onal Information					
Appeal ID: 24369		Project Address: 3132 SE 31st Ave				
Hearing Date: 11/25/20		Appellant Name: Bjorn Larson				
Case No.: B-006		Appellant Phone: 503.347.6218				
Appeal Type: Building		Plans Examiner/Inspector: Hend Barghouti				
Project Type: residentia	al	Stories: 2 Occupancy: R-3 Construction Type: V-B				
Building/Business Nan	ne:	Fire Sprinklers: No				
Appeal Involves: Alteratoric an existing structure	ation of an existing structure,Addition	LUR or Permit Application No.: 20-120387-RS				
Plan Submitted Option	: pdf [File 1] [File 2]	Proposed use: ADU				
Requires  Code Modification or  Alternate Requested	•	an attached ADU that would employ heavy timber constructions that falls within the 3ft minimum separation requiring fire				
Proposed Design	plans detailed by the engineer. In ac stairs and landing. This portion of the guideline that require fire rating. Plea In the case where a porch or deck is no adjacent porch or deck within 3 feeither noncombustible or heavy timb components supporting only the dea R301.5 shall be constructed using the Supporting posts for porches and dethickness.  Joists or beams supporting porches thickness.	llow construction

DECK DETAILS

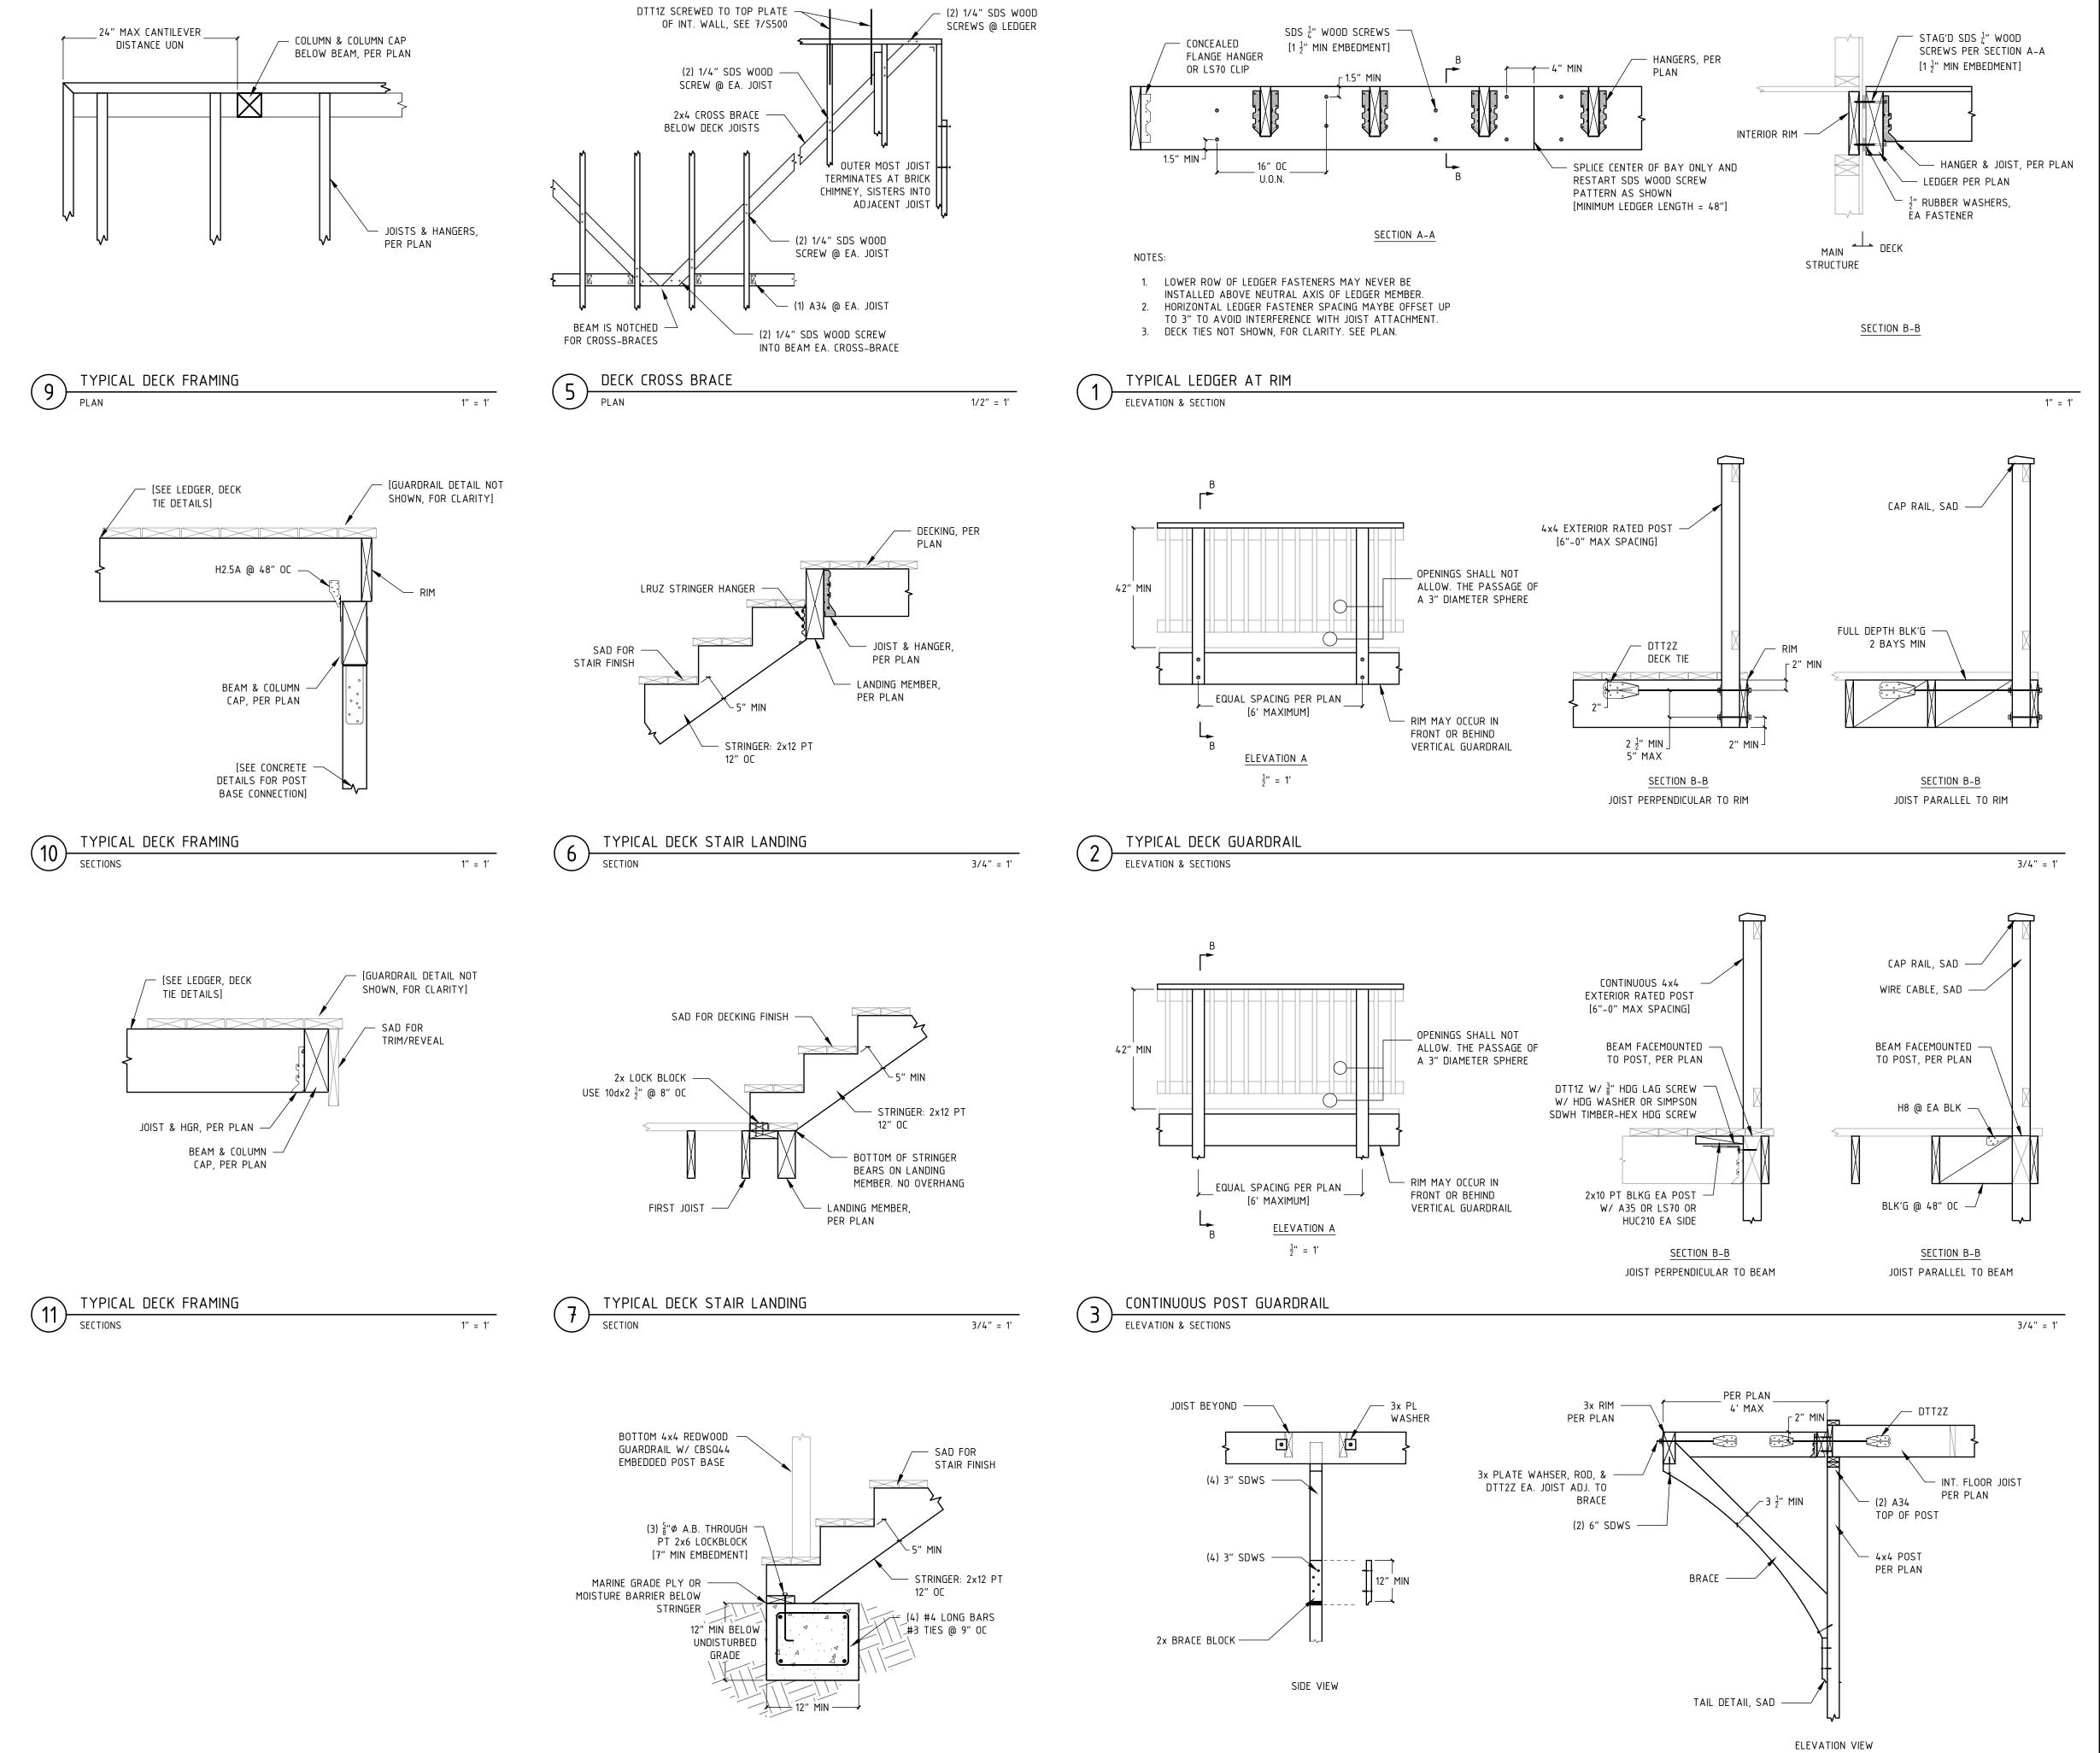
Reason for alternative	interior side of the walls common to	ms that the largest concern for Life-Safety is with fire rating the both dwellings. The proposed construction of this ADU has a characterior however, is less clear since the proposed ADU

addition over an existing garage which is part of the existing dwelling but where the least amount of "dwelling" occurs. Finally, from a practical standpoint, the small and open square footage of the ADU lends itself to an "obvious" path of egress.

Taking into consideration these particulars we believe the intent of the code under appeal is maintained.
